802.3dj D1.2

Comment Resolution

Electrical Track

Adee Ran (Cisco), 802.3dj Electrical Lead Editor
Matt Brown (Alphawave), 802.3dj Chief Editor
Howard Heck (TE), Editor, Clause 178 and Annex 176C

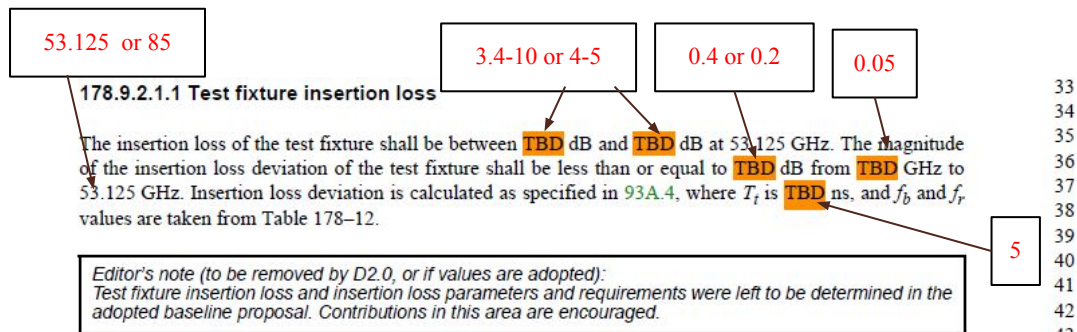
Use:

ILdd between 3.4 dB and 10 dB at 53.125 GHz
ILD magnitude up to 0.4 dB from 0.05 GHz to 53.125 GHz
T_t is 0.005 ns

PROPOSED ACCEPT IN PRINCIPLE.

The comment addresses an open TBD and the comment and the suggested remedy are reasonable, but consensus is not obvious.

Figure 178-8—Channel mode conversion insertion loss to insertion loss difference

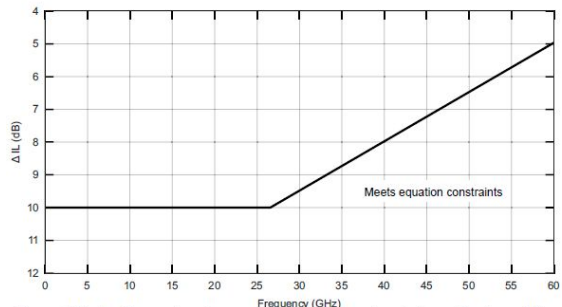
CI 179 SC 179.11.5 P375 L15 # 102
 Ran, Adee Cisco Systems, Inc.
 Comment Type TR Comment Status D CA specifications

In 802.3ck the specification of this parameter are the same in KR (163.10.5) and CR (162.11.5). Therefore we can use the same equation and figure as in KR (178.10.5).

Rename the parameter to "mode conversion insertion loss" and use the same equation and figure as in 178.10.5. Implement with editorial license.
 Change the reference in the text to point to the correct equation and figure.

Proposed Response Response Status W
 PROPOSED ACCEPT.
